Contaminated Land Site Audit Report (SAR)

Department of Veteran Affairs

51, 53 and 55 Headfort Street, Greenslopes Queensland

BC200195.01

client:	DEPARTMENT OF VETERAN AFFAIRS		
project:	DVA GREENSLOPES 51/53/55 HEADFORT STREET, GREENSLOPES, QLD		
title:	SAMPLE LOCATION PLAN		
project no:	754-BNEEN282781	figure no:	FIGURE 2
		rev:	A

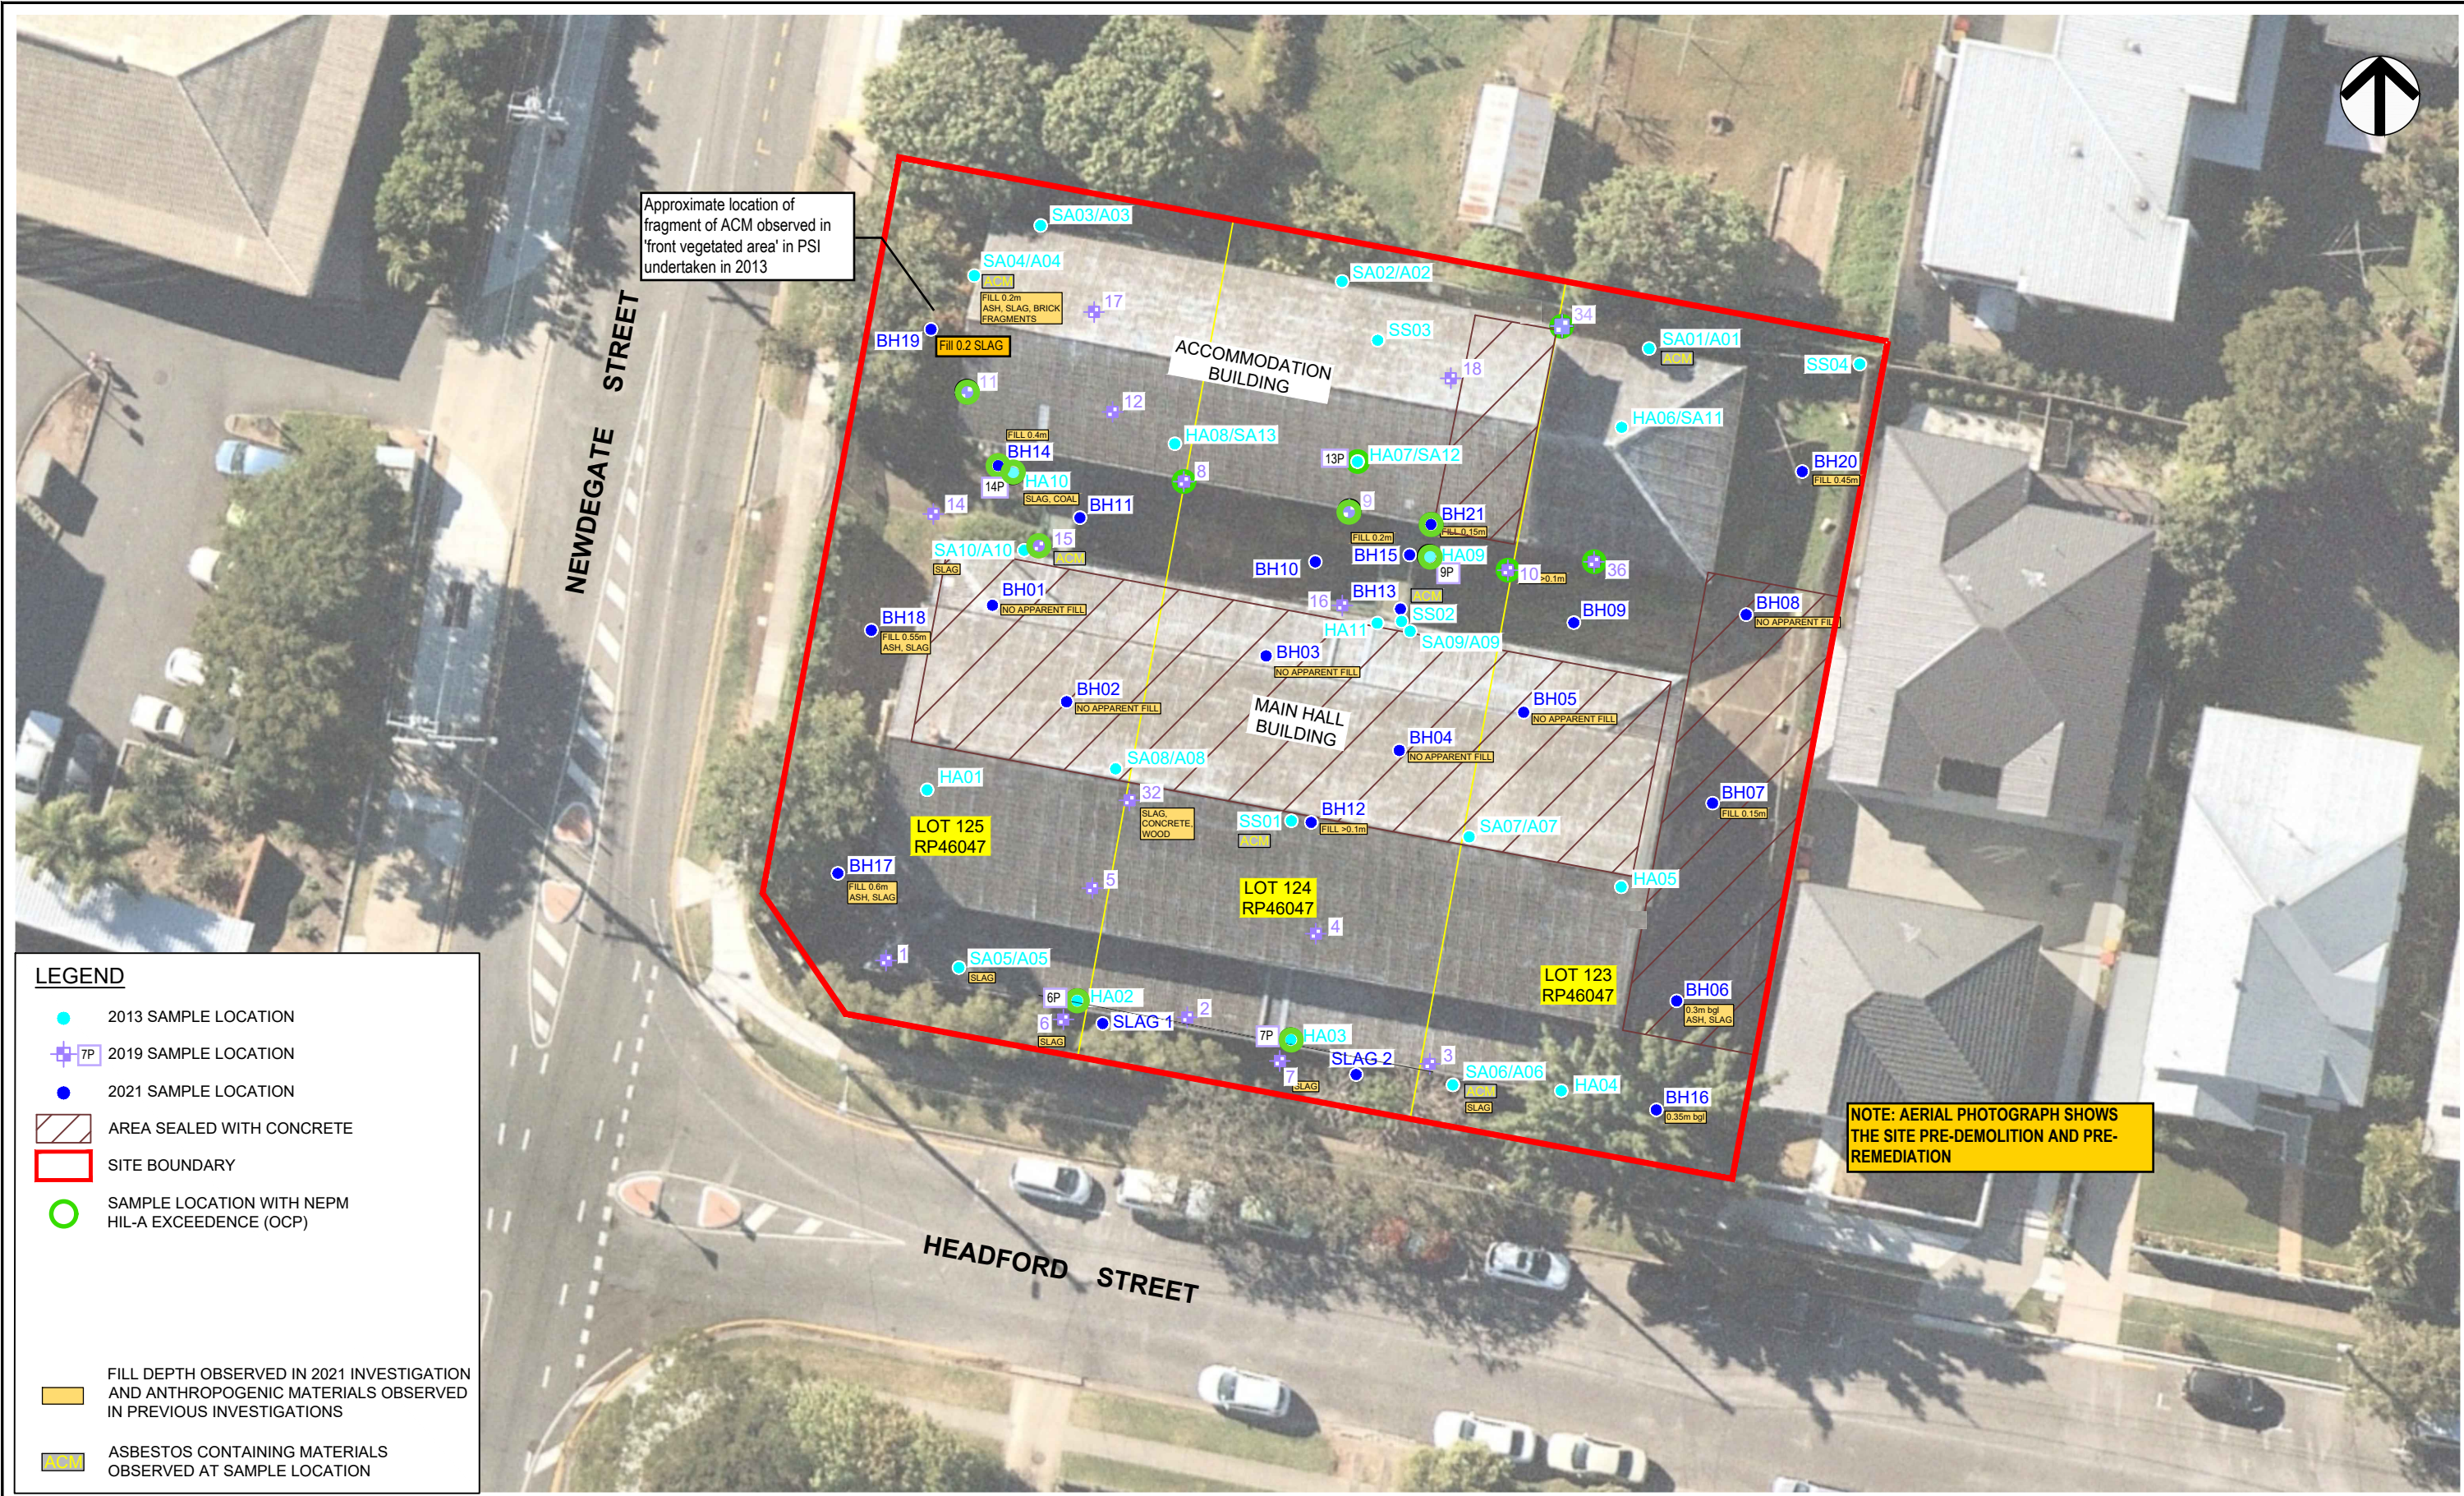
91	LC (Epic)	Rev D, 12/05/2024	5-Jun-24	3.2.2 Scope of Works	-	-	Please review and update sample location ID, specifically HA06, HA07 and HA08 to HA06/SA11, HA07/SA12 and HA08/SA13 as indicated in Figure 2	Refer to amendments to Table 3-3	Addressed	30-Jul-24	Closed
92	LC (Epic)	Rev D, 12/05/2024	5-Jun-24	3.2.2 Scope of Works	-	-	The report doesn't refer to SG01 and SG02 as indicated in Figure 2	SG01 and SG02 appear to have been included as an error in the figure in the 2013 report and have been removed from Figure 2, Appendix A. No analytical data or logs are associated with these sample locations.	Addressed	30-Jul-24	Closed
93	LC (Epic)	Rev D, 12/05/2024	5-Jun-24	3.2.2 Scope of Works	-	-	Table 3-4: AS4482.1-2005 - first time used	Refer to amendments to Table 3-4	Addressed	30-Jul-24	Closed
94	LC (Epic)	Rev D, 12/05/2024	5-Jun-24	3.2.2 Scope of Works	-	-	Table 3-4 "Analytical suite": identify which samples were analysed for OCPS and metals and which for asbestos	Refer to amendments to Table 3-4	Addressed	30-Jul-24	Closed

95	LC (Epic)	Rev D, 12/05/2024	5-Jun-24	3.3.2 Scope of Works	-	-	Confirm where the 5 locations are on a figure i.e., sample numbers 6P, 7P, 9P, 13P and 14P	Refer to amendments to Section 3.3.2 and Figure 2 and Figure 3 Appendix A	Tiny error - there's an extra 6P south of the southern boundary that needs to be removed	30-Jul-24	Open
96	LC (Epic)	Rev D, 12/05/2024	5-Jun-24	3.3.2 Scope of Works	-	-	Bullet 2, sub-bullet 3. Some sample numbers appear to be missed from Figure 2 - 32, 34 and 36 were only identified	Bullet 3 was repeated from the 2019 Investigation report. Bullet 3 has been amended to stated that 3 locations were also collected for delineation purposes including 32, 34 and 36. It has been assumed that this was the purpose of these samples.	Noted	30-Jul-24	Closed
97	LC (Epic)	Rev D, 12/05/2024	5-Jun-24	3.3.2 Scope of Works	-	-	Bullet 3, sub-bullet 2. confirm what field observations this is in reference to	Reference to field observations has been removed. Field observations relating to samples 32, 34 and 36 were not included in the 2019 report.	Noted	30-Jul-24	Closed

92	Rev D, 12/05/2024	5-Jun-24	3.2.2 Scope of Works	-	-	The report doesn't refer to S501 and S502 as indicated in Figure 2	S501 and S502 appear to have been included as an error in the figure in the 2013 report and have been removed from Figure 2, Appendix A. No analytical data or logs are associated with these sample locations.	Addressed					30-Jul-24	Closed
93	Rev D, 12/05/2024	5-Jun-24	3.2.2 Scope of Works	-	-	Table 3-4: AS4482:1-2005 - first time used	Refer to amendments to Table 3-4	Addressed					30-Jul-24	Closed
94	Rev D, 12/05/2024	5-Jun-24	3.2.2 Scope of Works	-	-	Table 3-4 "Analytical suite" identify which samples were analysed for OCPS and metals and which for asbestos	Refer to amendments to Table 3-4	Addressed					30-Jul-24	Closed
95	Rev D, 12/05/2024	5-Jun-24	3.3.2 Scope of Works	-	-	Confirm where the 5 locations are on a figure i.e., sample numbers eg. TP, BP, GP and LBP	Refer to amendments to Section 3.3.2 and Figure 2 and Figure 3 Appendix 1	Addressed					30-Jul-24	Closed

96	Rev D, 12/05/2024	5-Jun-24	3.3.2 Scope of Works	-	-	Bullet 2, sub-bullet 2. Some sample numbers appear to be missed from Figure 2 - 32, 34 and 36 were only identified	Bullet 3 was repealed from the 2019 investigation report. Bullet 2 has been amended to state that 3 locations were also collected for delineation purposes including 32, 34 and 36. It has been assumed that this was the purpose of these samples.	Addressed					30-Jul-24	Closed
97	Rev D, 12/05/2024	5-Jun-24	3.3.2 Scope of Works	-	-	Bullet 3, sub-bullet 2, confirm what field observations this is in reference to	Reference to field observations has been removed. Field observations relating to samples 32, 34 and 36 were not included in the 2019 report.	Addressed					30-Jul-24	Closed
98	Rev D, 12/05/2024	5-Jun-24	3.3.3 Key Findings	-	-	Table 4.5 "Analytical Suite" - why wasn't asbestos identified?	Terra Tech Coffey has assumed that comment relates to Section 3.3.3 and not Table 4.5 in Section 4.5.2. Asbestos was not analysed in samples collected in the 2019 investigation and hence was not included in the findings in Section 3.3.3.	Addressed					30-Jul-24	Closed

client:	DEPARTMENT OF VETERAN AFFAIRS		
project:	DVA GREENSLOPES 51/53/55 HEADFORT STREET, GREENSLOPES, QLD		
title:	SUMMARY OF HUMAN HEALTH EXCEEDANCES AND FILL DEPTH		
project no:	754-BNEEN282781	figure no:	FIGURE 3
		rev:	A

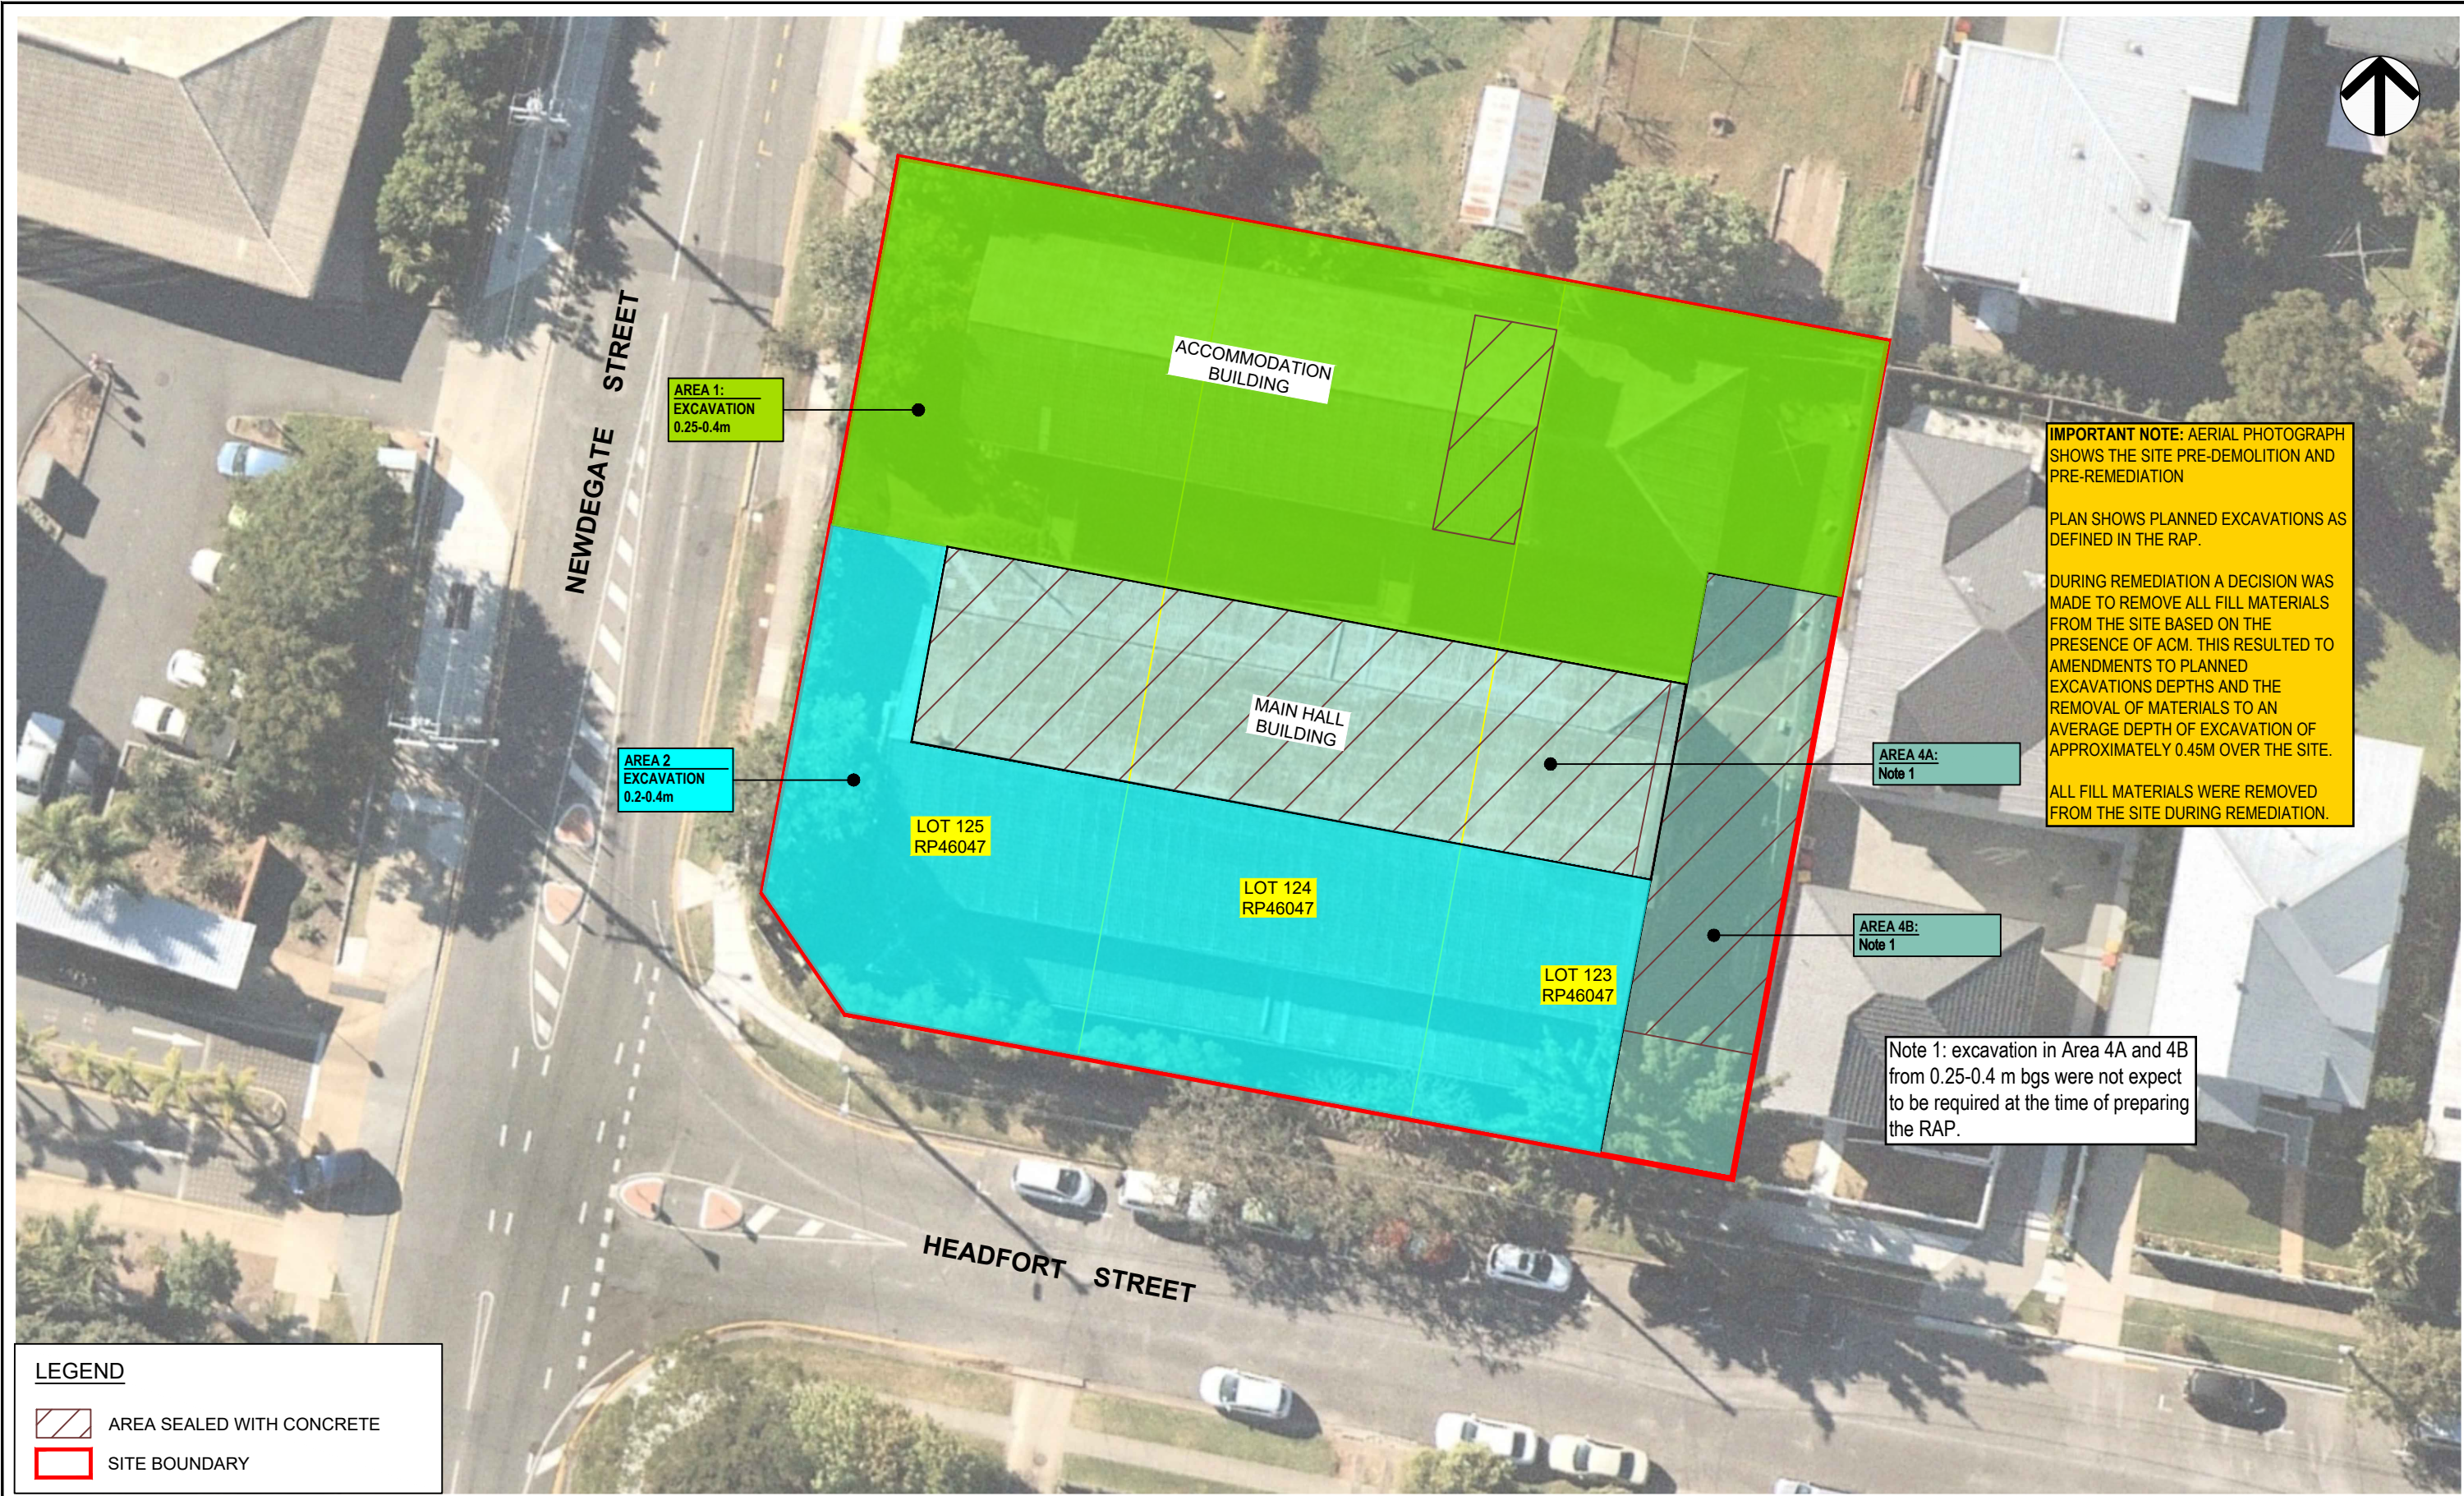
62	NA	Figure 3	(1) [Legend] Clarify if the "areas sealed with concrete" was still present at the time of this RAP document (2) Appears to illustrate the fill depths for only: (a) the 2021 investigation sampling locations; and (b) other previous investigation locations, only if there's the presence of ash, slag, ACM &/or other anthropogenic materials (wood, brick, etc.). Please show the depths to fill (or state "no apparent fill") for the 2019 sampling locations and other locations with prefixes of HA, SA, SG, SS, and A. (3) Clarify if the ACM was observed at the surface or within fill material (and at what depth)	Please refer note added to the figure. Refer to additional comments on Item 61. Fill depths were included in Figure 3 where the depth of fill was proven. This included locations in the 2021 investigation and a limited number of locations in other previous investigations (e.g. S404/A04). Where the depth of fill has been proven it is shown on the figure. Anthropogenic materials reported in the 2021 and other previous investigations were also included in this figure. ACM was not observed in 2021, and was observed at ground surface in previous investigations. Please refer to additional comments on Item 25.	Noted.	-	-	-	3/08/2023	Closed
